SUBJECT: Forwards answers to NRC 910321 station blackout questions.

Subject: 10 CFR §50.63, *Loss Of All Alternating Current Power*
R. E. Ginna Nuclear Power Plant
Docket Number 50-244

RG&E Answers To The NRC's March 21, 1991 Station Blackout Questions
Page 1 of 4

Design Analysis
Ginna Station
Sizing of Vital Batteries

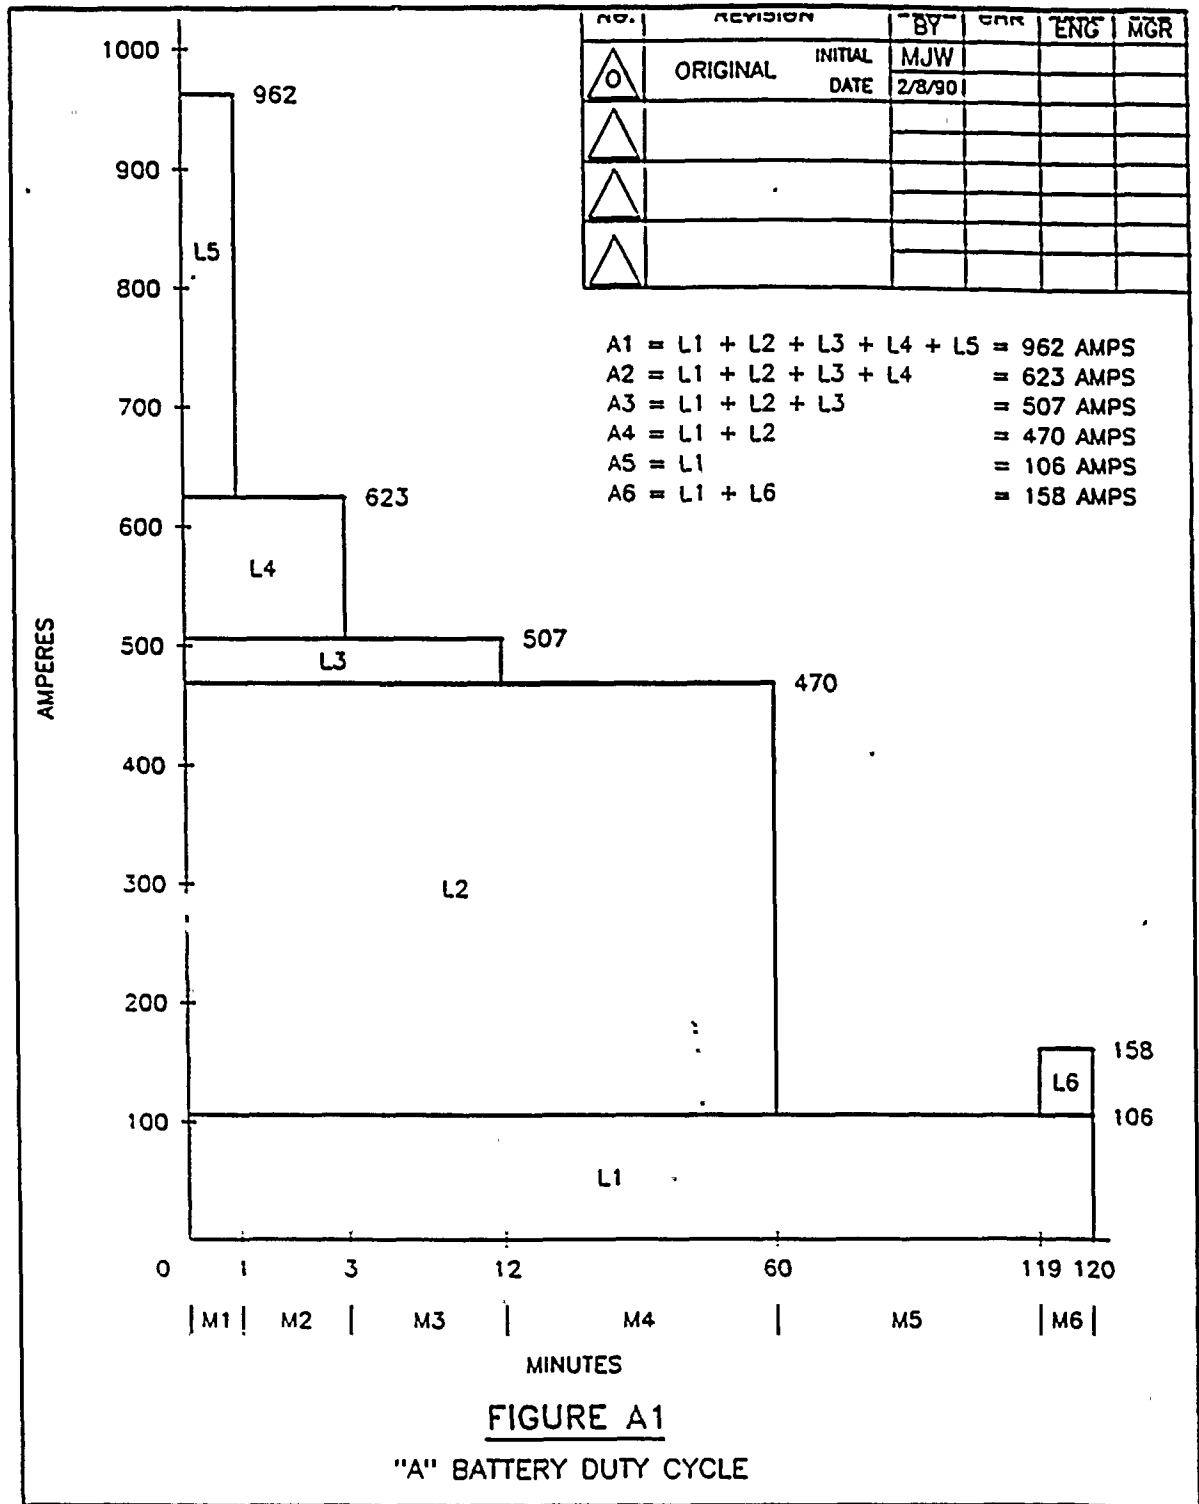
Provide the battery loads and the battery capacity calculation which was performed to verify that the installed Class 1E batteries have sufficient capacity to provide power for all connected loads during a four hour SBO event.

- 6.1.1 The loads representing the battery duty cycles are shown in Figures A1 and B1. Individual loads are shown on Tables A1 and B1. The loads are further broken down in Tables A2 and B2, Motor Loads, Tables A3 and B3, D.C. special Loads, and Tables A4 and B4, D.C. Miscellaneous Loads.

Response: The requested information and analyses are included in Attachment 1. As noted on the cover memo, several of the larger DC loads on the station batteries are being removed during the refueling outage that is now underway. Therefore, the attached analyses are conservative.

- 6.2.2 The load data for entry on the work sheet is obtained from the battery duty cycle, Figures A1 and B1.
- 6.2.3 The battery data is obtain from the GNB Battery Specification Sheets, Reference 3.6.
